Your Ref: SSD 7919

Council Ref: DA371/17

RE: Redevelopment of Loreto School (Masterplan, Stage 1 and concept Stage 2 and 3)

North Sydney Council appreciates the opportunity to provide further comment on the concept proposal and Stage 1 development for the Loreto School campus.

Figure 1 – Extract from Height of Building Map in NSLEP 2013

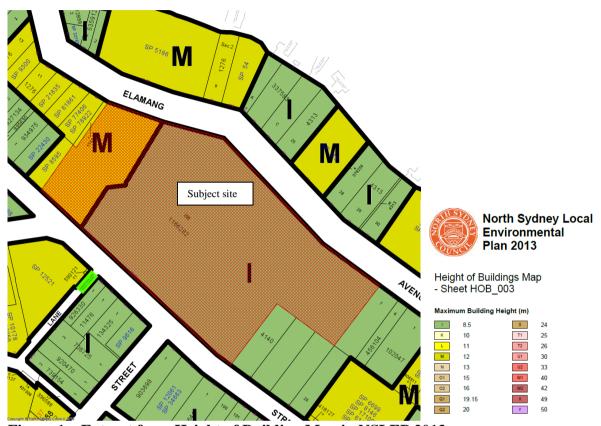
Clause 4.3(3) of NSLEP 2013 states that the maximum permitted building height on the site is 12 meters over the portion of the site which is zoned R4 High Density Residential. The works of most significance in the Stage 1 Western Precinct include the 7 story learning hub and an overall height of 14.5 metres exceeding the height limits for this zoning (12 metres).

Additionally, works to future stages of the overall proposal will lie over the portion of the site subject to the lesser 8.5 metre height control and exhibit breaches to this control of up to 14.7 metres. Residential premises adjoining the site are typically 2-3 storey residential dwellings (R2 Low Density zone to the eastern end of the site) or low rise residential flat buildings (at the Western end of the site) according to zone.

North Sydney Council is of the view that the scale of the New Buildings particularly the new additions to the western building (Learning hub) located close to the adjoining boundary site are incompatible with the sites adjoining and opposite along Carabella Street and Elamang Avenue. Existing buildings at the eastern end of the sites are zoned R2 Low Density Residential with a maximum permissible building heights of 8.5 m (**refer to Figures 1 and 2 below**).
